## REPORT TO CITY PLAN COMMISSION

**Item:** Preliminary Plat – Fourth Addition to Clearwater Creek

**Petitioner's Request:** The owner/applicant is proposing to subdivide property for single-family residential development.

PRELIMINARY PLAT  
**FOURTH ADDITION TO CLEARWATER CREEK**

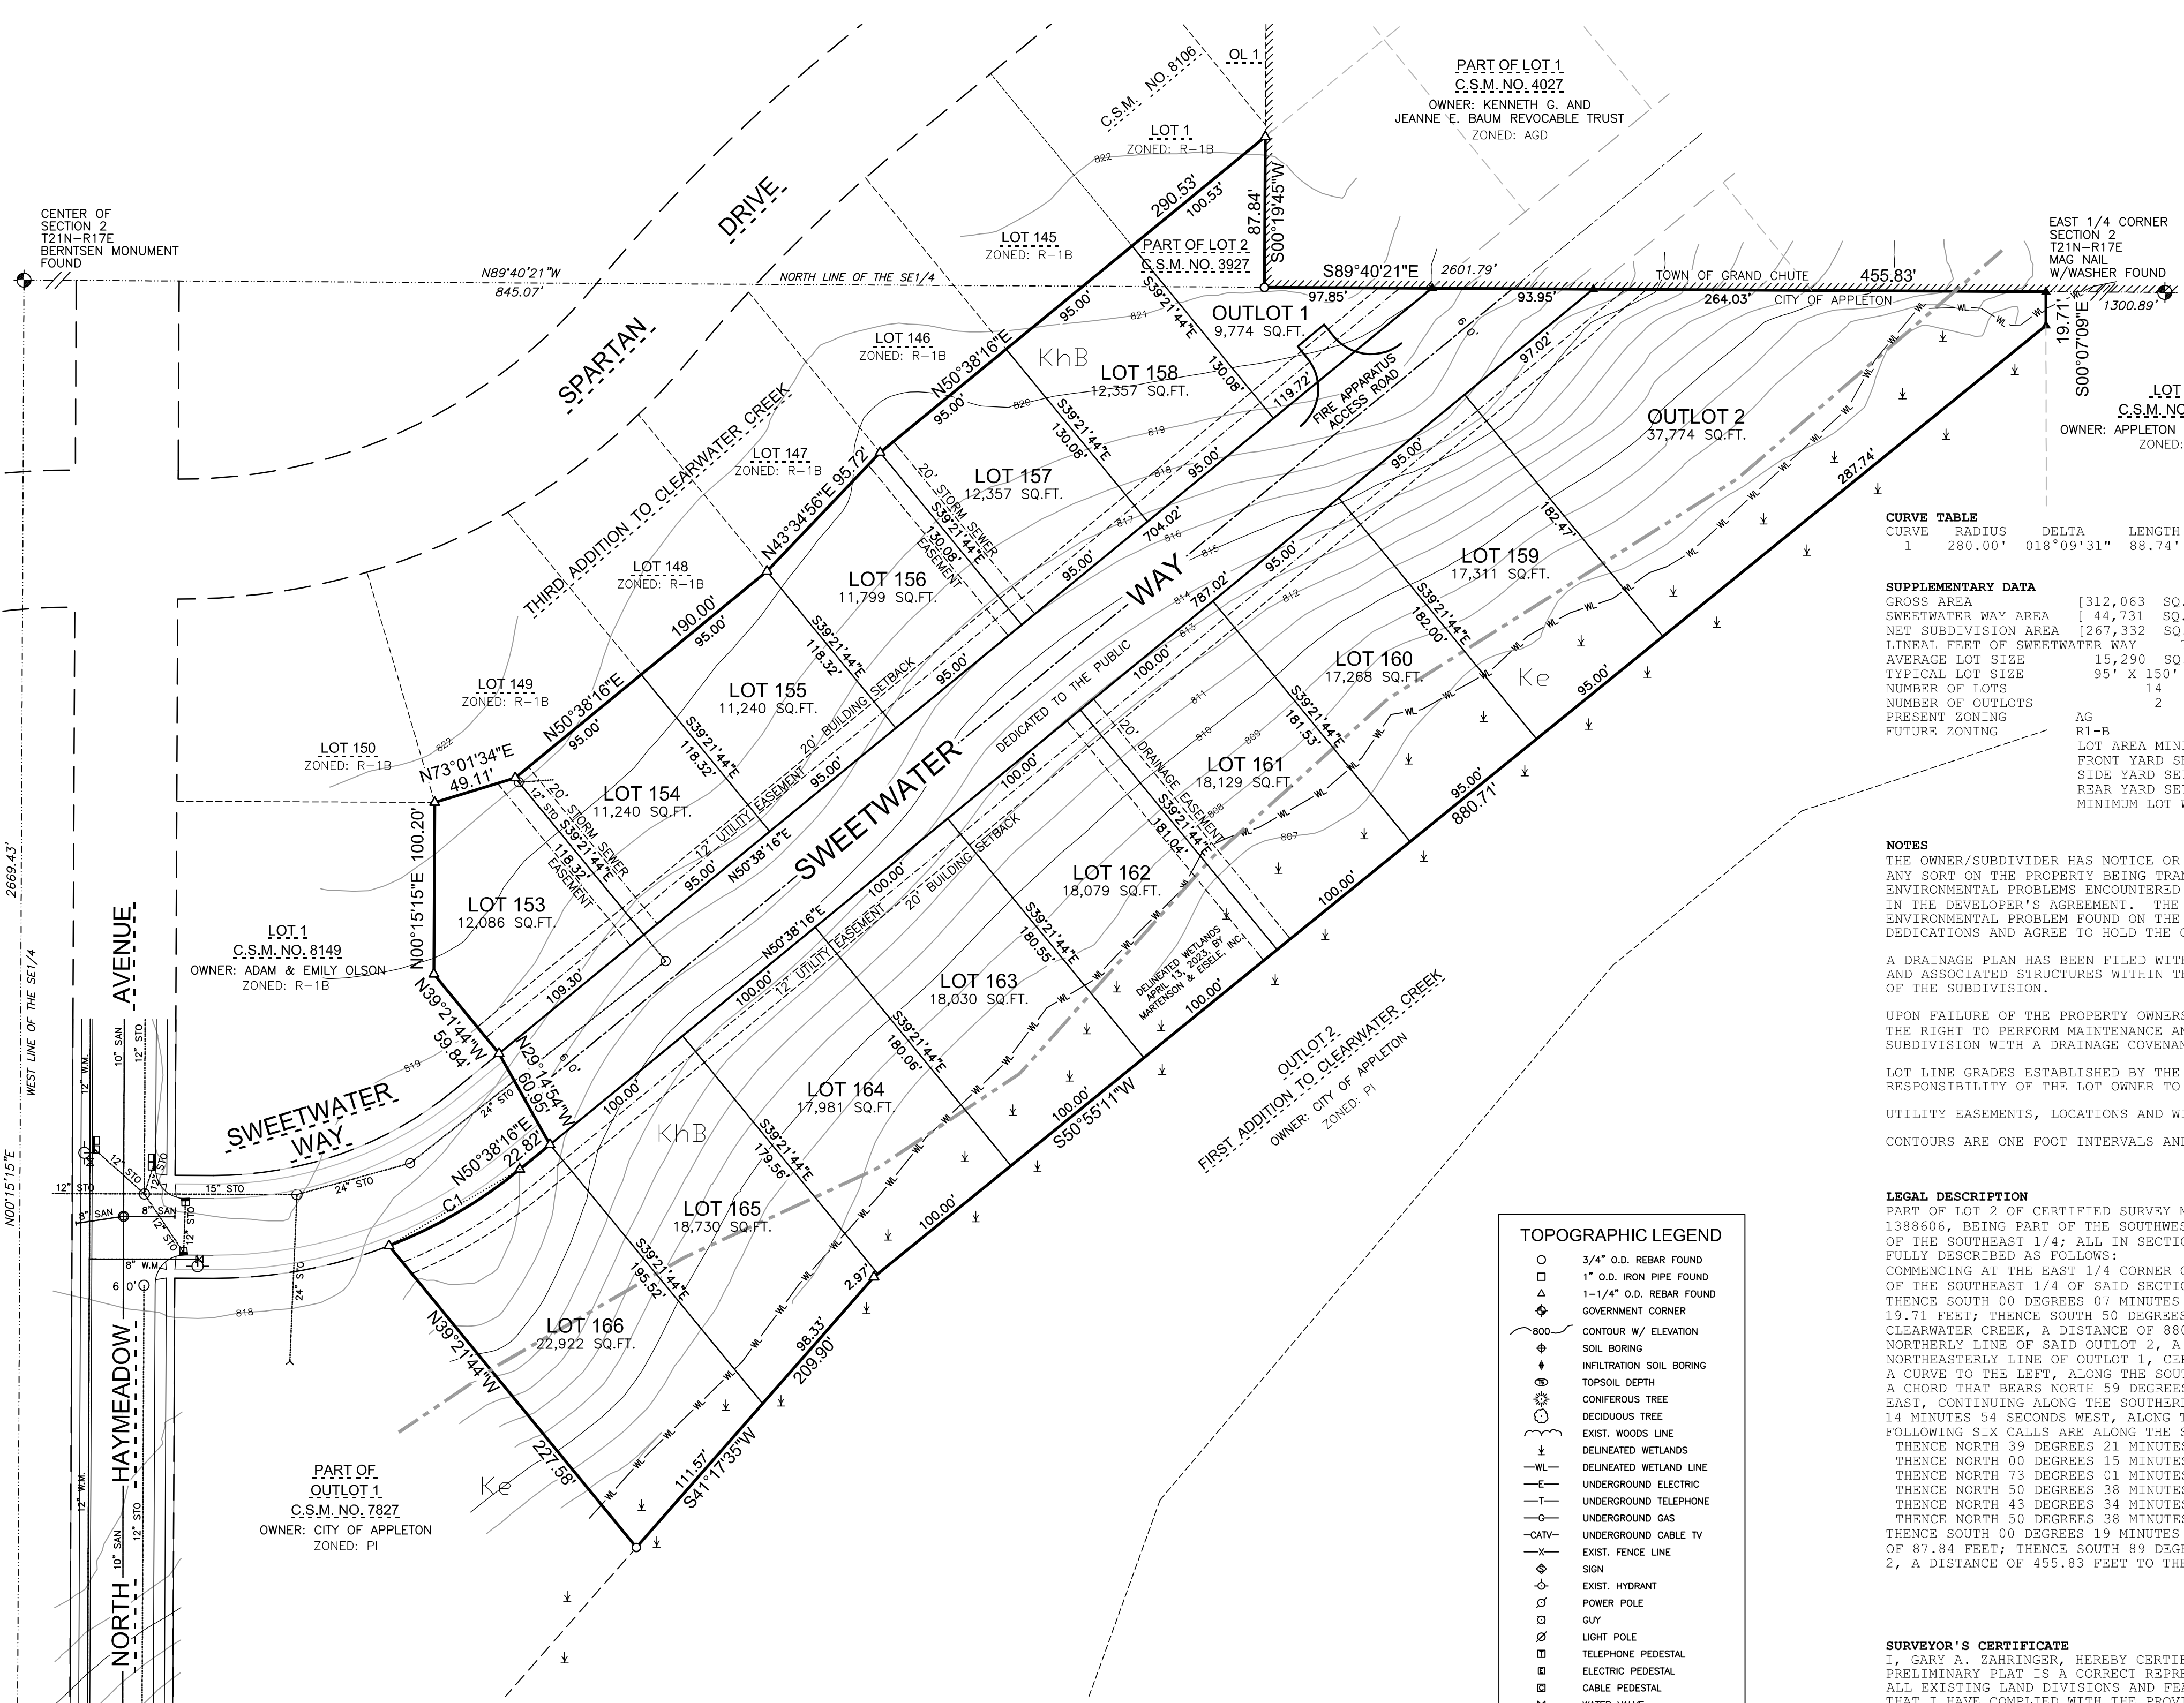
- The drive from Spartan to Richmond would count as a secondary access for the fourth phase of Clearwater Creek. This drive would need to be maintained as such. For the fifth phase of Clearwater Creek, this access will not be acceptable as a secondary access.
- The fire apparatus turnaround at the northern limits of East Sweetwater Way is acceptable as long as it is designed to meet the standards defined in Appendix D from the 2018 IFC. The applicant has been provided with the design standards and has incorporated them into the design as shown on the preliminary plat.

3. Show the extents of the Protective Area per the stormwater management requirement and verify that Lots 160 -162 are buildable.
4. Add the necessary drainage easements per the stormwater management review comments.

5. Show the Normal Water Level and 100-yr Water Level of the stormwater pond.
6. Show the overland flow paths.
7. List the intended purpose/uses for Outlots 1 and 2 on the Final Plat.

8. Hydrant benchmarks should specify the benchmark location on the hydrant, for Waterous type hydrants the “City” location is the “Top shoulder” of the hydrant.

9. The “Fire Apparatus Access Road” shown across a portion of Outlot 1 should have an easement area specified on the Final Plat. One option could be a Temporary Turn Around Easement, with verbiage similar to: Temporary Turn Around Easement, shall be released automatically upon the dedication, construction, acceptance, and Northeasterly extension of Sweetwater Way.
